Technology Inclusive Content of Application Project Workshop

May 19, 2021

Technology Inclusive Content of Application Project (TICAP)

Workshop #2
May 19, 2021

Figure 1. Relationship of TICAP to an Advanced Reactor License Application

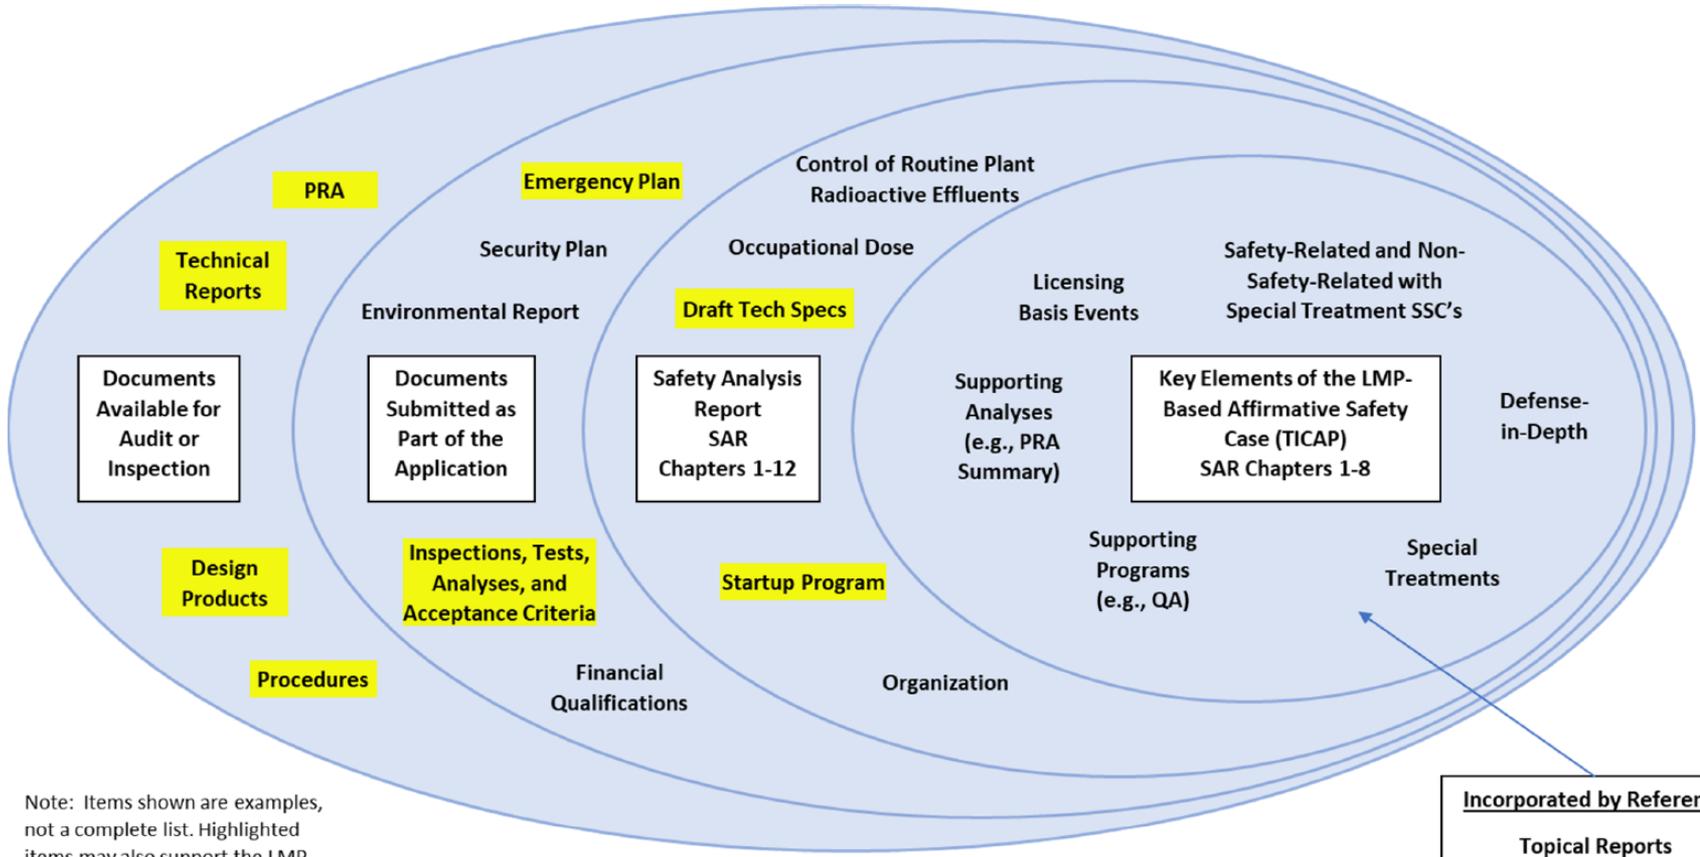
- *The term “safety case” is not currently used in NRC licensing processes.*
- *Need alignment on what a safety case is and, equally important, what it is not.*
- TICAP Discussion
 - TICAP proposes a definition for safety case derived from those established by the International Atomic Energy Agency (IAEA) and respected national regulatory bodies.
 - TICAP concurs that elements of an application and the NRC’s decision-making are outside the scope of the technology-inclusive, risk-informed, performance-based process, including but not limited to physical security, cyber security, IAEA safeguards, etc.

TICAP definition: “An affirmative safety case is a collection of technical and programmatic evidence which documents the basis that the performance objectives of the technology-inclusive Fundamental Safety Functions (FSFs) are met by a design during design specific Anticipated Operational Occurrences (AOOs), Design Basis Events (DBEs), Beyond Design Basis Events (BDBEs), and Design Basis Accidents (DBAs). This is accomplished by the following:

- Identifying design-specific safety functions that are adequately performed by design-specific SSCs;
- Establishing design-specific features (programmatic, e.g., inspections, or physical, e.g., diversity) to provide reasonable assurance that credited SSC functions are reliably performed and to demonstrate the adequacy of defense-in-depth.”

Principal Design Criteria (PDC)

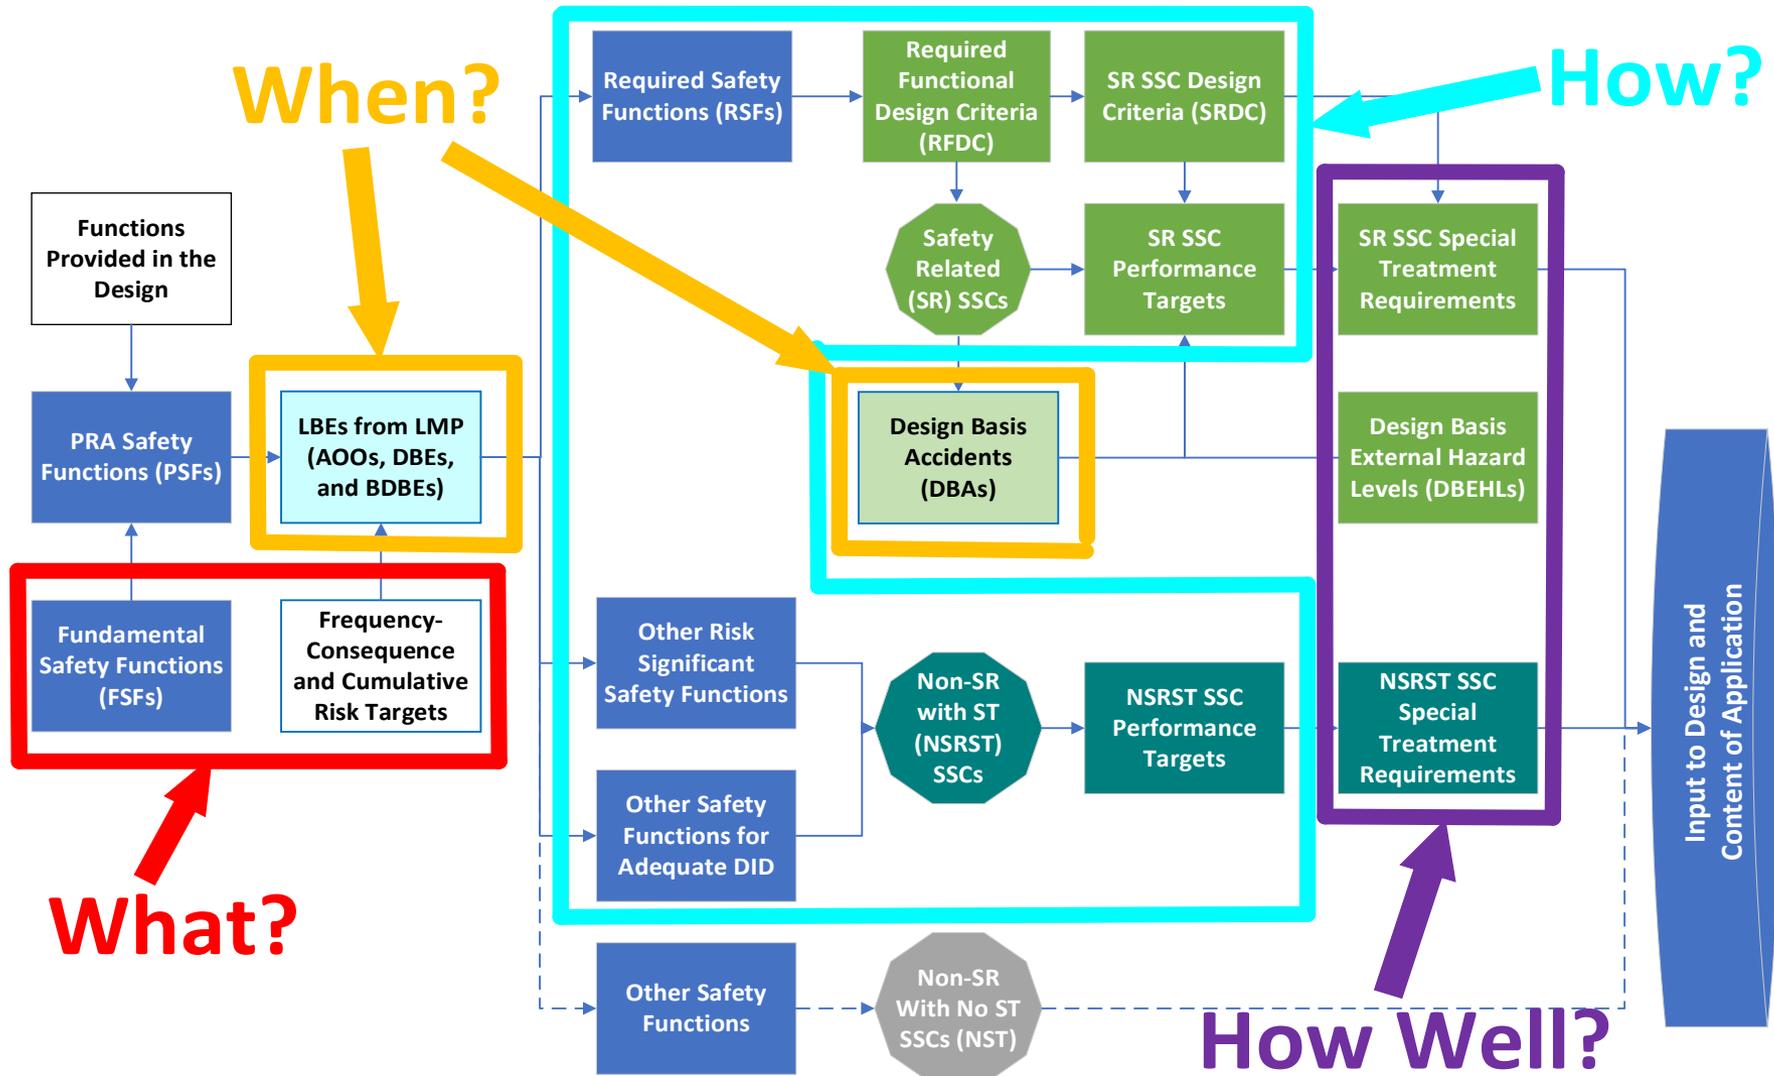
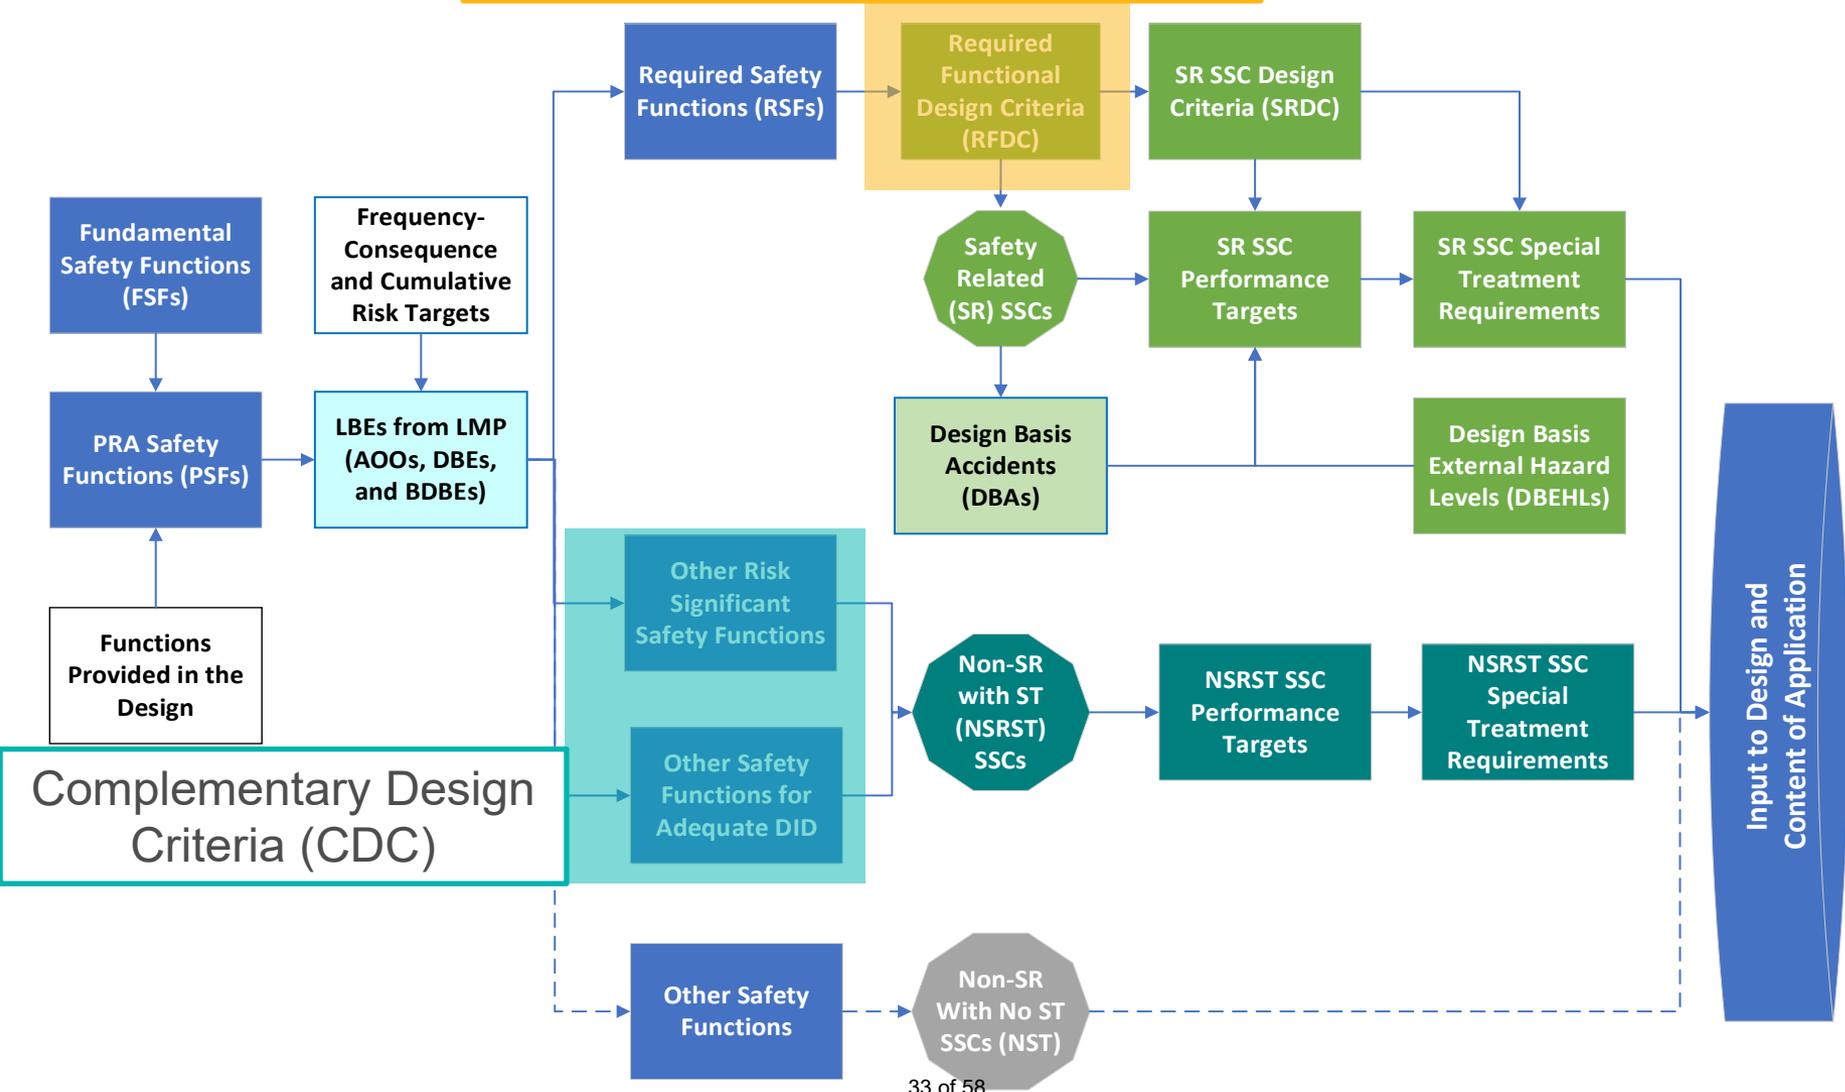
- *The guidance for inclusion of principal design criteria (PDC) may be incomplete, since only "LMP outcomes" are addressed, and other topics from Part 50 App. A (like Monitoring Fuel & Waste Storage) are not clearly included for consideration*
- *Comment 6: The TICAP methodologies are trying to adapt the PDC concept to the affirmative safety case approach and equate the PDC to those associated with RSFs. In that approach, considering non-reactor sources could have associated RSFs and PDCs if high-consequence events might be associated with such inventories. Other issues associated with the LWR GDC or ARDC may be addressed by other parts of an application.*

- The TICAP vision for PDC was preliminarily briefed during the 8/27/2020 public meeting on TICAP; however, the tabletop exercises were used to more clearly refine the TICAP definition of PDC within the LMP approach
 - » The next two slides provide the TICAP context for PDC
- Based on an affirmative safety case using the LMP approach, PDC answer the question “How do plant capabilities (functional and structural) demonstrate that the Fundamental Safety Functions are met?”
- The question of “How well do these capabilities need to be performed to provide reasonable assurance of adequate protection to the public?” are addressed by LMP although “how well” items are not identified as PDC by the TICAP guidance
- NRC Comment 6 (for Topic 6) correctly reflects that these “other issues associated with the LWR GDC or ARDC may be addressed by other parts of an application”

- Based on the definition of PDC within an LMP-based affirmative safety case, the TICAP team considers the guidance for inclusion of PDC to be complete
- The use of the LMP approach establishes a comprehensive set of requirements for meeting the performance objectives of the Fundamental Safety Functions through the systematic development of RSFs, RFDC, SRDC, and additional PSFs and design margins
